EGG-RTAP-10936

TECHNICAL EVALUATION REPORT
PUMP AND VALVE INSERVICE TESTING PROGRAM
MAINE YANKEE ATOMIC POWER STATION

Docket Number 50-309

Figure 1
Safety Injection System (Typical of three)

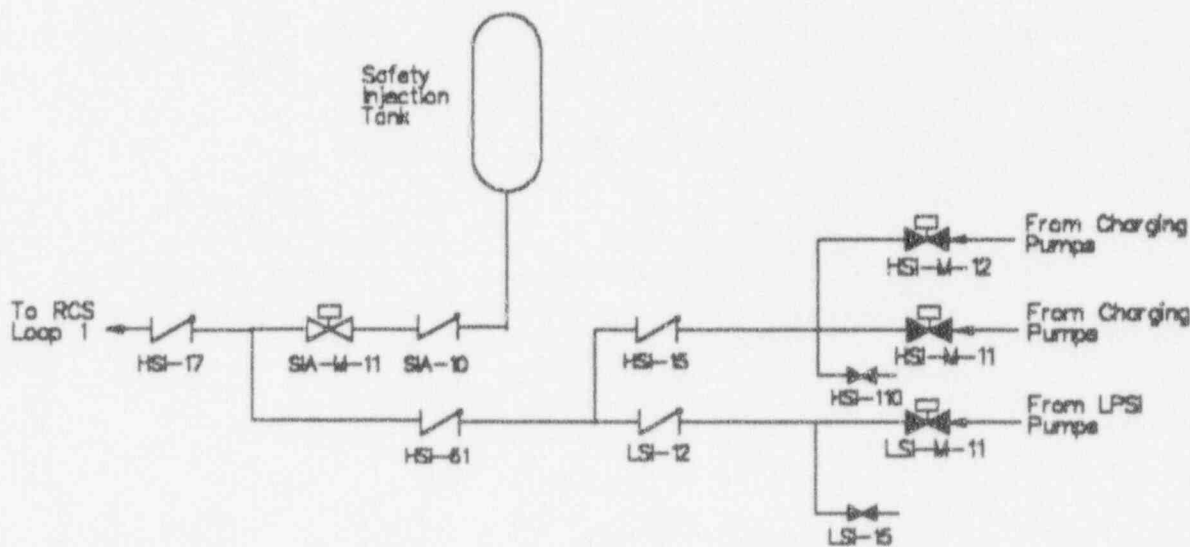
10. The justification in DTJ-32 for not full or part-stroke exercising during power operation reads "... the LPSI pumps do not develop sufficient head to overcome RCS pressure." However, the justification does not provide a reason that flow could not be established through the HPSI/LPSI header valves, HSI-61, -62, and -63, and the combined injection header valves, HSI-17, -27, and -37 (see Figure 1), using the centrifugal charging pumps. This testing need not be performed if it is impractical, however, if it is not performed, the basis should be documented in the program plan. Another concern is the full-stroke exercise of the combined injection header check valves, HSI-17, -27, and -37. The proposed alternate test indicates that these valves will be full-stroke exercised open during cold shutdowns using RHR. Since the combined injection header accident condition flow would also include HPSI and safety injection tank flow, it is not clear how the licensee verifies that the proposed testing of these valves meets the full-stroke open criteria of GL 89-04, Position 1. The licensee should respond to these concerns.
